Attachment 2 to AEP:NRC:0916AB
Proposed Revised Technical Specification Pages

3/4.1 REACTIVITY CONTROL SYSTEMS

3/4.1.1 BORATION CONTROL

Figure 3.1-3 REQUIRED SHUTDOWN MARGIN

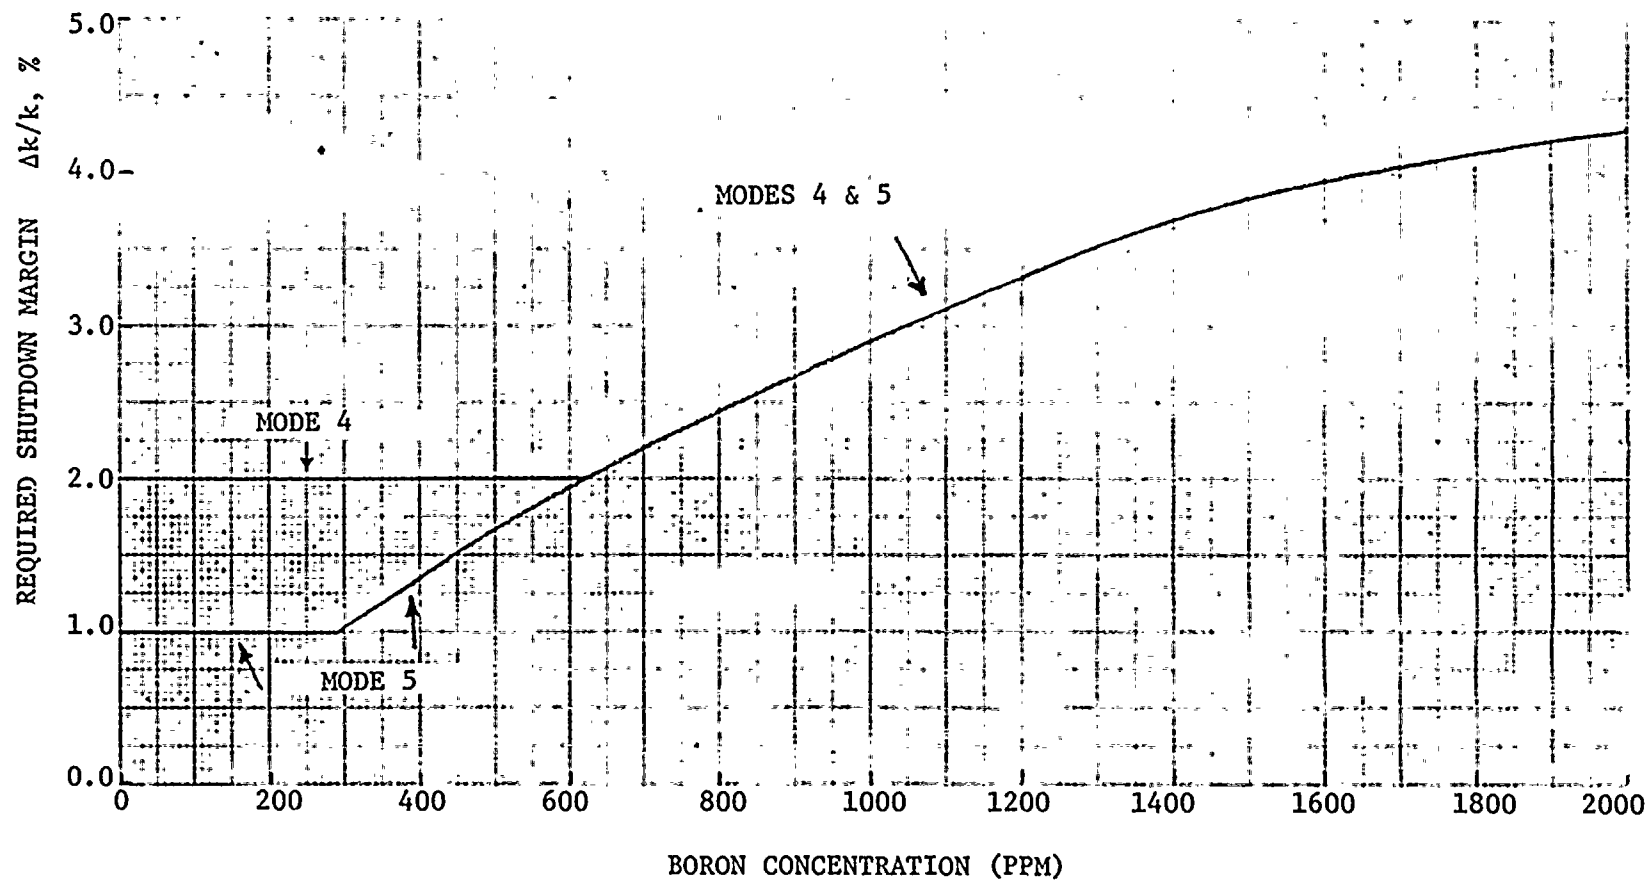
1. Greater than or equal to $2.0\% \Delta k/k$ when operating with one or more Reactor Coolant Loops in accordance with Specification 3.4.1.3.
2. Greater than the value shown in Figure 3.1-3 when operating with no Reactor Coolant Loops but one or more Residual Heat Removal Loops in accordance with Specification 3.4.1.3.

1. Greater than or equal to $1.0\% \Delta k/k$ when operating with one or more Reactor Coolant Loops in accordance with Specification 3.4.1.3.
2. Greater than the value shown in Figure 3.1-3 when operating with no Reactor Coolant Loops but one or more Residual Heat Removal Loops in accordance with Specification 3.4.1.3.

In shutdown MODES 4 and 5 when heat removal is provided by the residual heat removal system, active reactor coolant system volume may be reduced. Increased SHUTDOWN MARGIN requirements when operating under these conditions is provided for high reactor coolant system boron concentrations to ensure sufficient time for operator response in the event of a boron dilution transient.
